4th Session SEISMIC EFFICIENCY OF LARGE STRUCTURES (RECOMMEN DATIONS, CHECKING AND SURVEILLANCE)

DISCUSSION

Paper 4/1 R. PRISCU, A. POPOVICI, C. STERE - ROMANIA

"The Consequences of Partially Grouted Joints Upon the Arch
Dam Seismic Behaviour"

Principal stresses σ_1 , σ_2 produced by hydrostatic pressure, according to the three analysed variants.

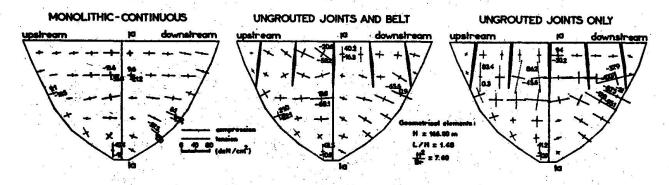
I believe that the ordinates of fig. 4 are all ten times too large and a decimal point should be added; also in fig. 7 I find it difficult to understand the large horizontal stresses in the area where the joints are ungrouted.

As to have a more complete picture upon the stress distribution of the three considered schemes (monolithic, partial grouted joints with and without stiffening crest belt), in the hereby enclosed figure the principal stresses σ_1 , σ_2 are presented, yielded by the hydrostatic pressure with the reservoir level up to the dam crest.
